Modular Firmware

V2.2.52_220518 Release Note

Device Model	DS-KD8003-IME1、DS-KD8003-IME2
Firmware Version	V2.2.52_220518
iVMS-4200 Version	Latest version
Hik-Connect APP	Latest version

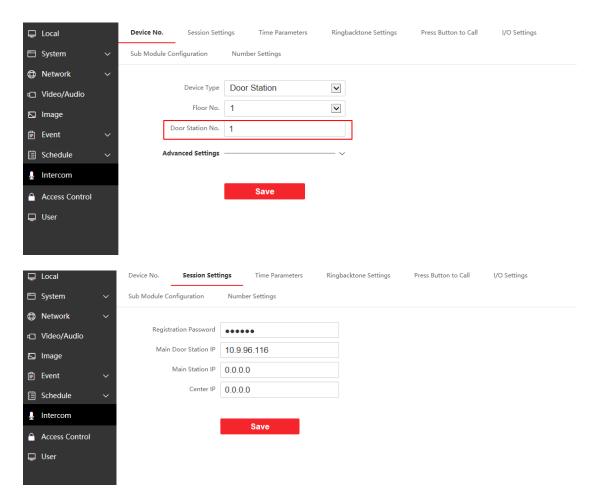
1 Since V2.2.50_210728, remote degradation of devices is not supported in all subsequent versions. When degradation occurs, it will prompt Upgrading failed.

Notice: Although the device can be degraded by serial port, the device will fail to start and cannot change the version by using serial port again, which means that the device will be completely unusable.

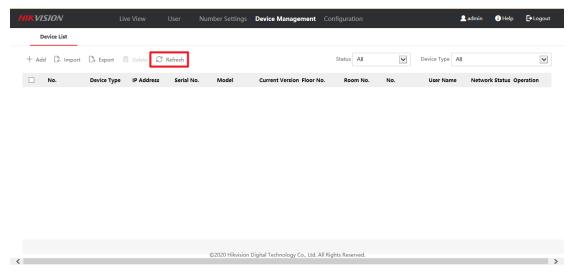
1. New refresh button is used to refresh the status of added devices

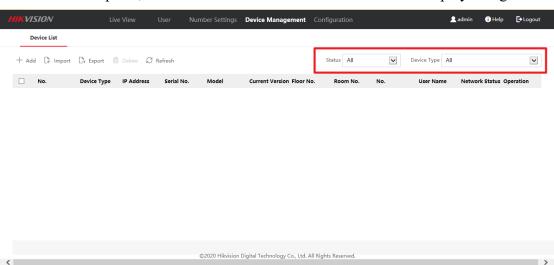
2. Added 'All' option, indoor station and sub-door station will be displayed together.
